REPLIES TO PRE BID QUERIES LOT 2 DATED 10.08.2022

NIT NO : PNM/PC 183/E 4017/NCB Dated 20.06.2022

SUB:GRID CONNECTIVITY TO TFL TO SUPPLY 90 MW POWER AND CONSTRUCTION OF 220 KV LILO GIS AT TALCHER FERTILIZERS LTD

TITLE
LAYOUT PLAN FOR BALANCE LAND DEVELOPMENT WORKS

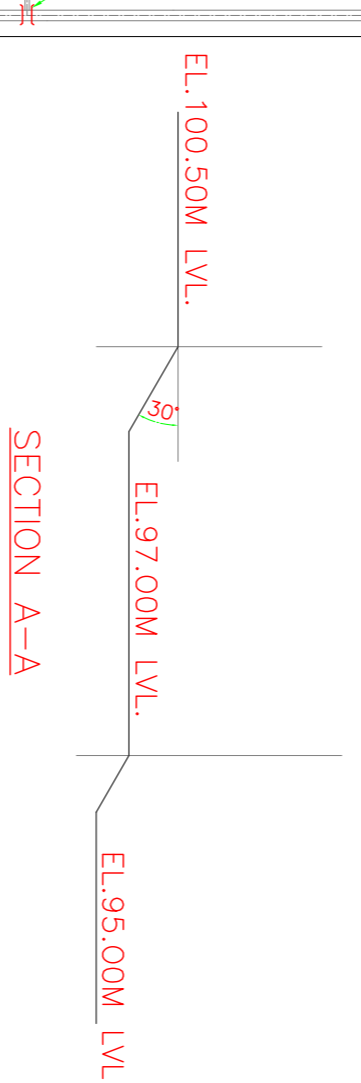
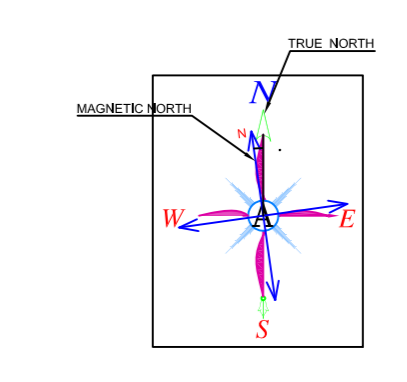
48	Section VI	347 of 1622	2	Section Project/ Scope of civil works	Soil Investigation report and contour plan	Please furnish, 1. Tender purpose Soil Investigation report or SBC Value 2. Contour plan or Avg NGL and proposed FGL level of Switchyard to ascertain the Site development work.	(1)Soil investigation report for the proposed area is not available. Soil related data of near by area is attached only for Reference purpose. As per NIT, Bidder has to conduct soil investigation within their area for detail design. Also, The Bidder may visit the Site to ascertain the Soil Parameters. Any variation in Soil Data shall not constitute a valid reason for any Additional Cost and shall not affect the Terms and Conditions of the Contract. Nothing extra what so ever shall be paid to the Bidder on account of any variation in Sub Soil Properties / Conditions. (2) Land development plan drawing and contour survey drawing is attached herewith for reference purpose.
